## HISTORIC AND DESIGN REVIEW COMMISSION

**HDRC CASE NO:** 2017-566  
**ADDRESS:** 402 CENTER ST  
406 CENTER ST  
139 N SWISS  
126 N CHERRY  
122 N CHERRY  
120 N CHERRY  
134 N SWISS  
130 N SWISS  
126 N SWISS

**OWNER:** K/T TX Holding, LLC  
**TYPE OF WORK:** Approval of a site plan for a twenty-four unit townhome development  
**APPLICATION RECEIVED:** October 24, 2017

## OHP-DRC Presentation (Case No. 2017-566)

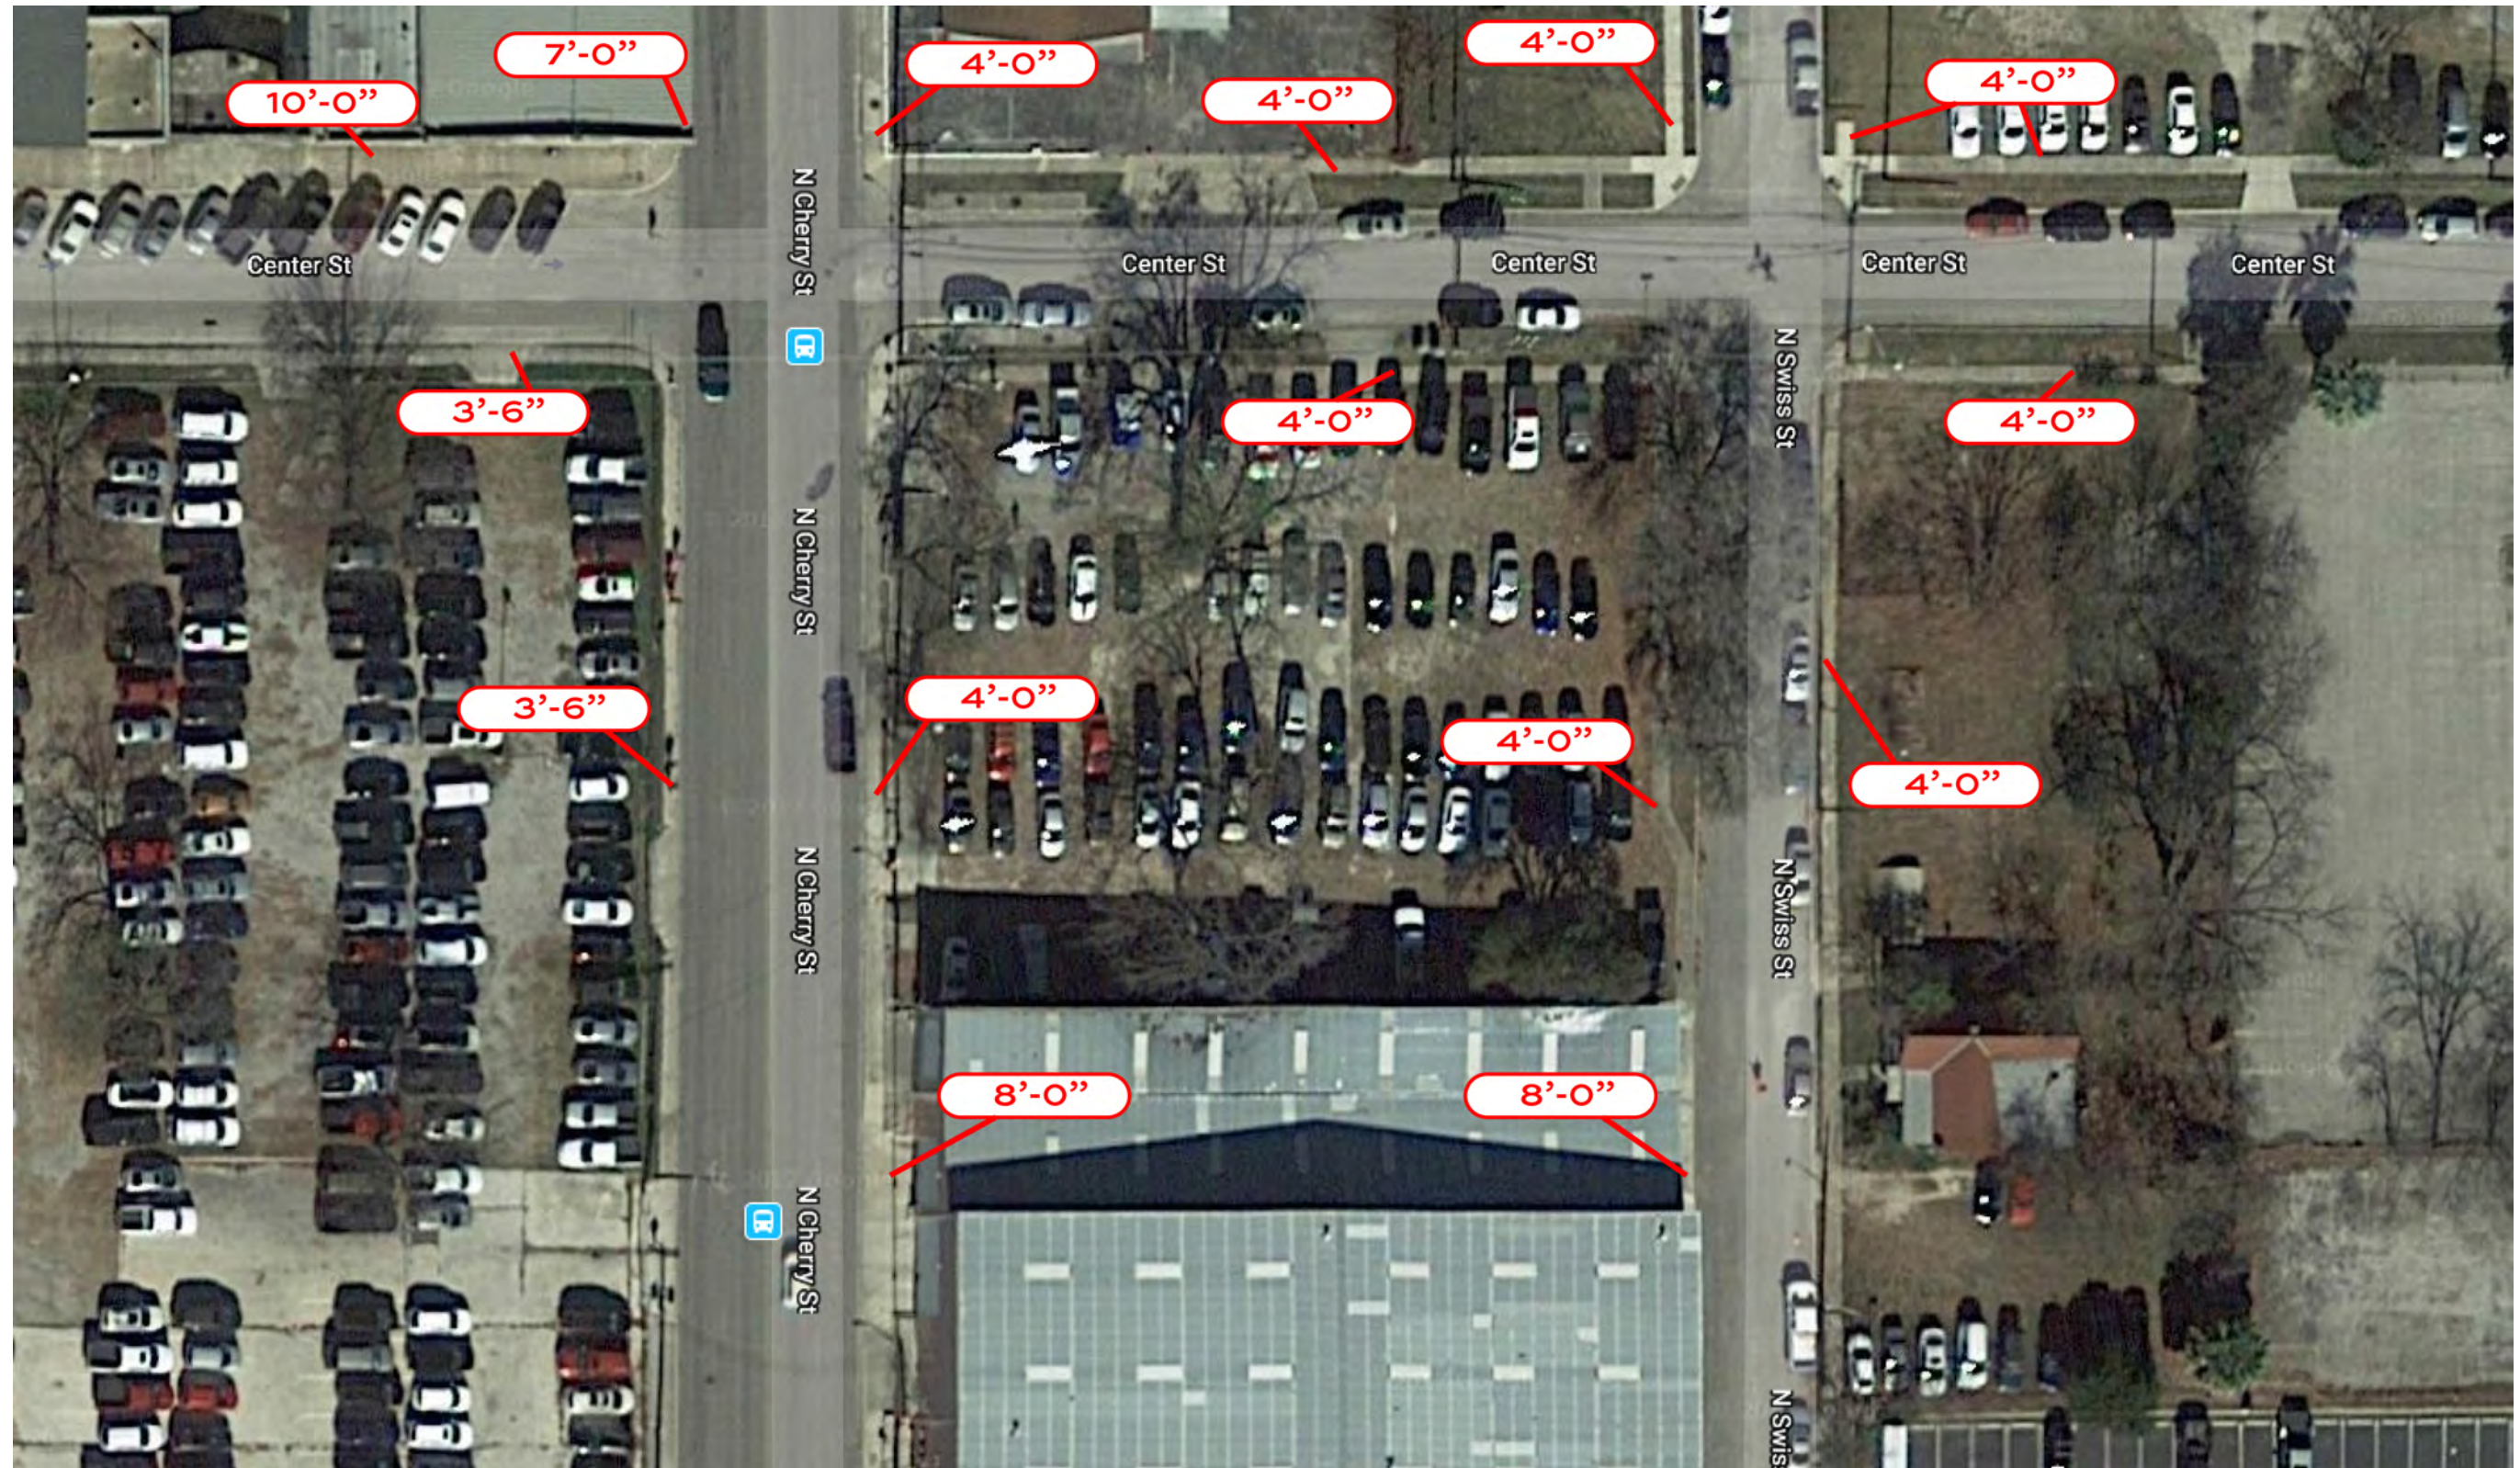
vii. That all sidewalks which intersect the sidewalk at Center feature a width and profile that is consistent with those found historically in the district.

All Aprons to be concrete 31'-0" wide. All Private Streets to be concrete 18'-0" wide with Roll-Over Curbs

Terramark: All Sidewalks on N Cherry St./Center St/N Swiss St. to be concrete 6'-0" wide per city code
